**CHANGE/ERRATA**

**ISSUE NO: 1 8/94**

Title: 5100B Instruction Manual  
Part Number: 926634  
Print Date: October 1992  
Rev.- Date: 1, 1/94

Figure B.

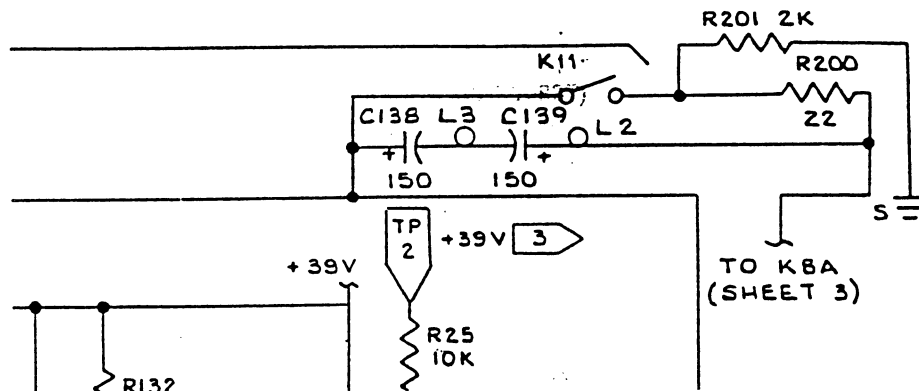
On page 7-44, Figure 7-15, add L2 and L3 as shown in Figure B:

**Figure C.**

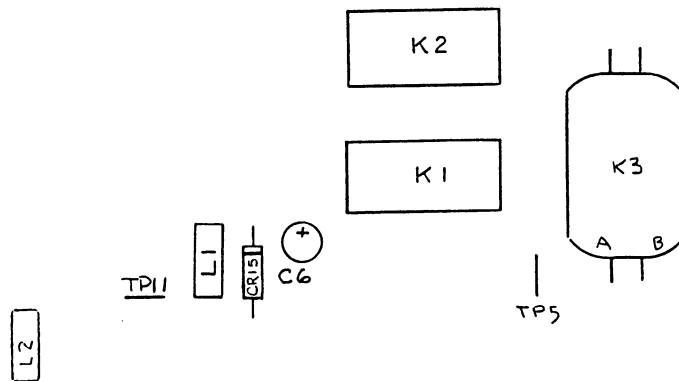
On page 5-66 and 7-39, Figure 5-17 and 7-14, add CR15 as shown in Figure C:

**Figure D.**

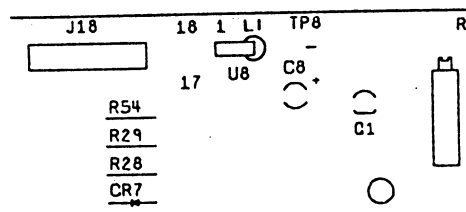
On pages 5-82, add 7-53, add L1 as shown in Figure D.

Figure C.

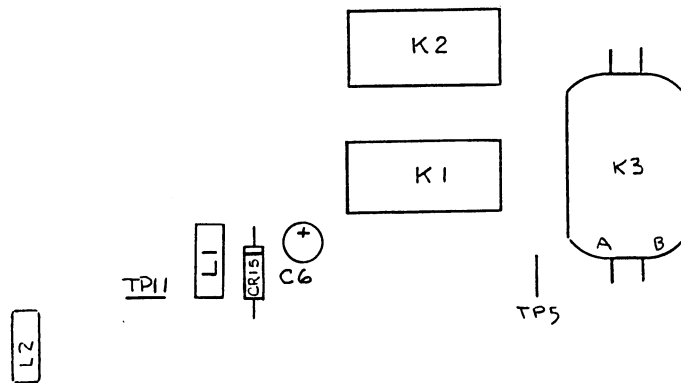
On page 5-66 and 7-39, Figure 5-17 and 7-14, add CR15 as shown in Figure C:

Figure D.

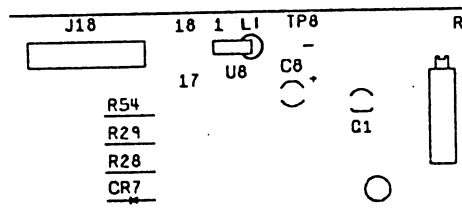
On pages 5-82, add 7-53, add L1 as shown in Figure D.

Figure H.

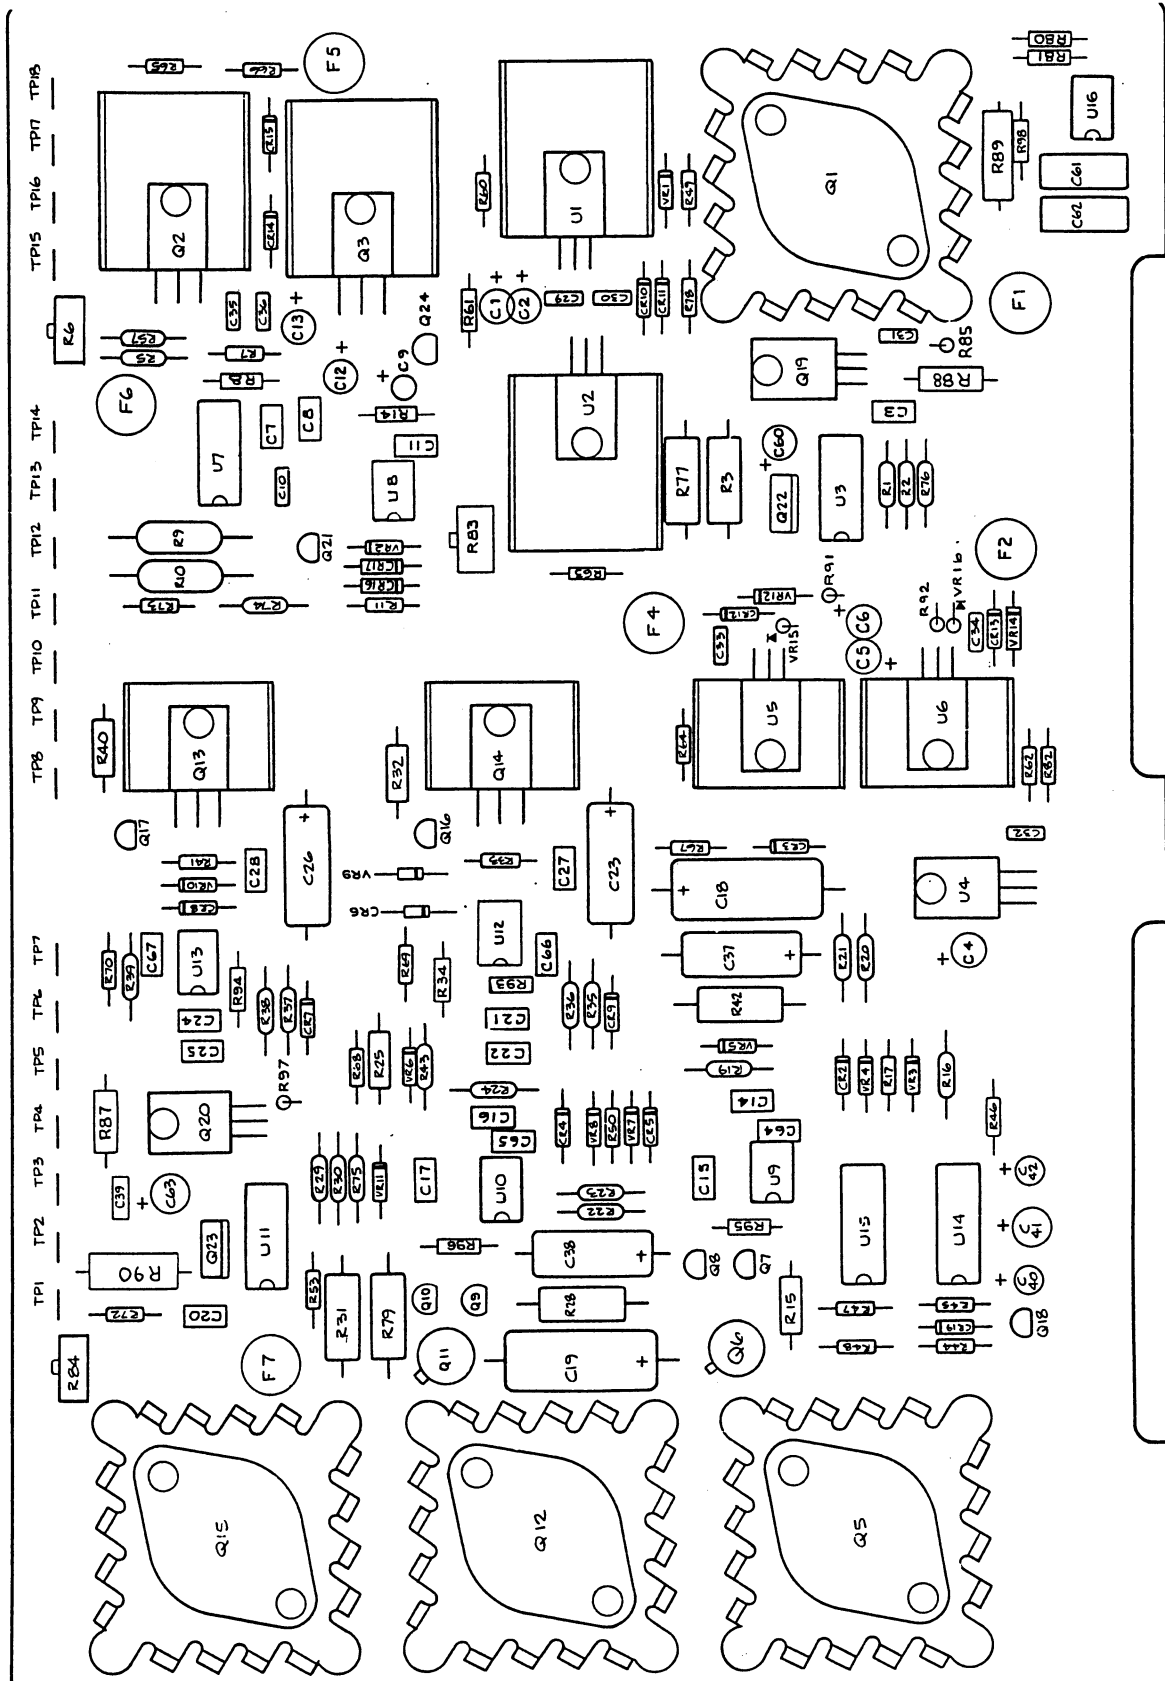
On pages 5-49 and 7-16, replace Figures 5-10 and 7-6 with Figure H.

Figure I.

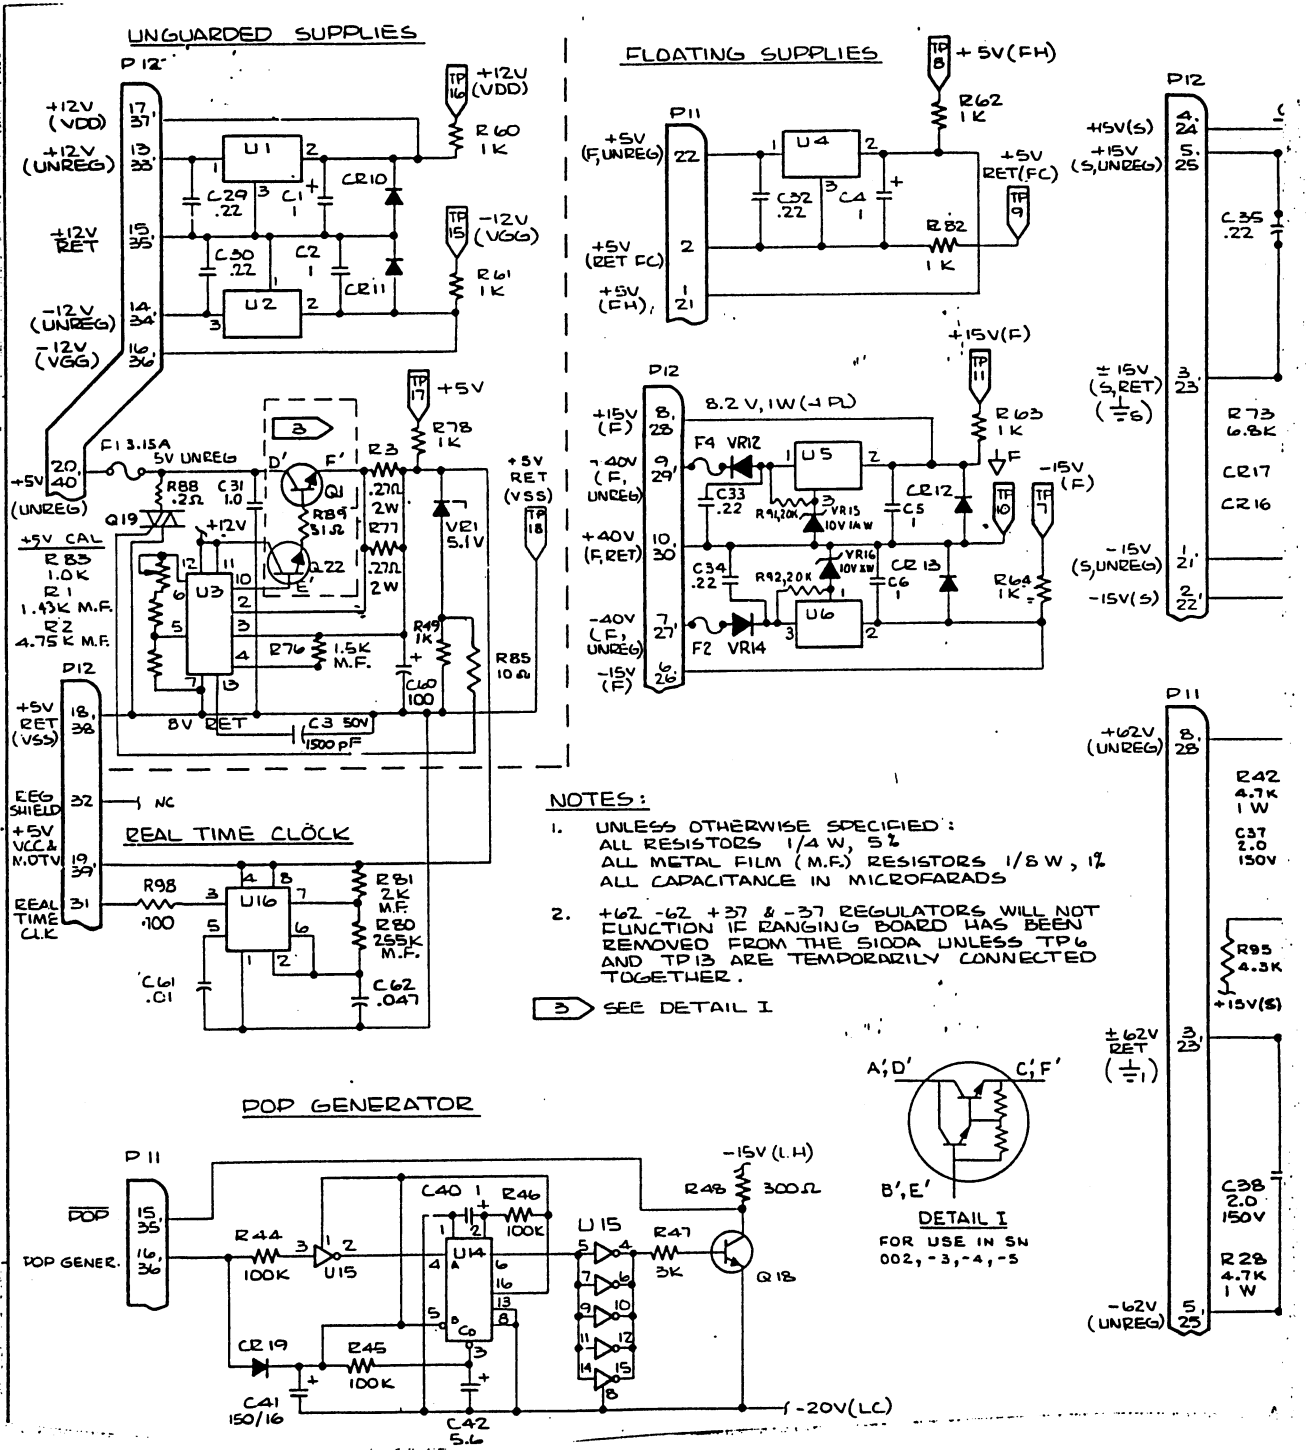
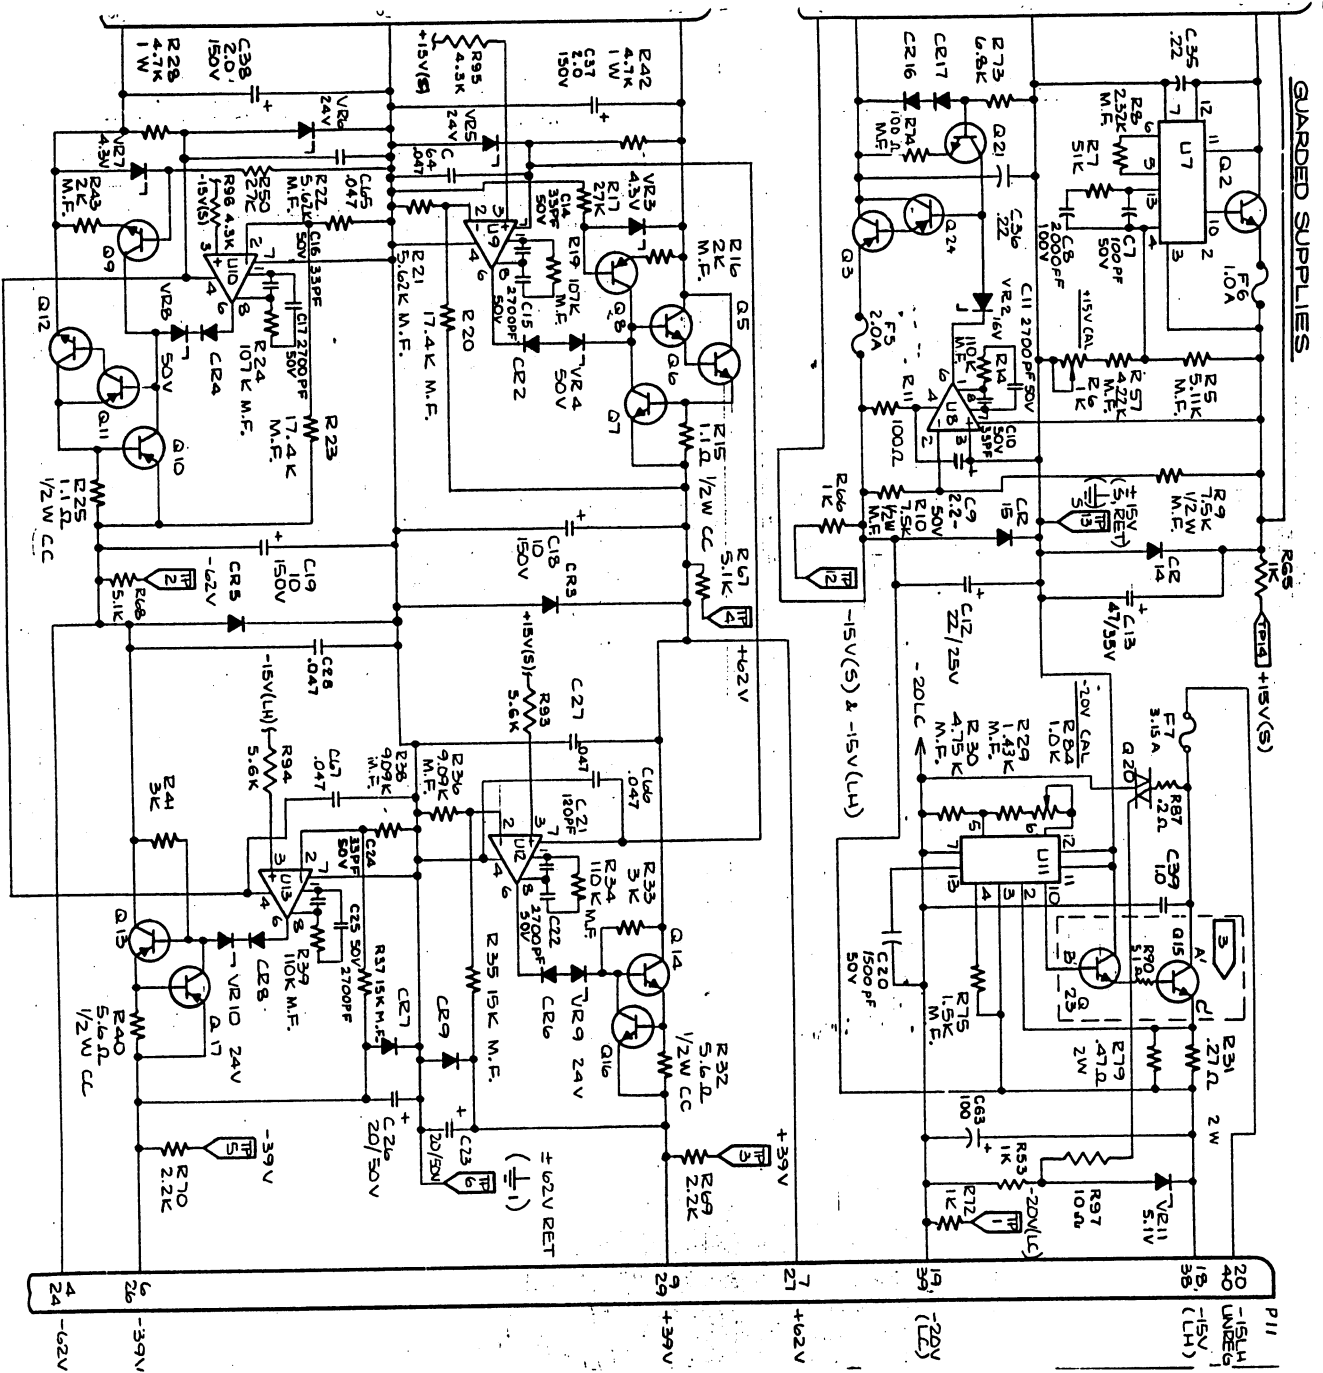
On page 7-17, replace Figure 7-6 with Figure I.
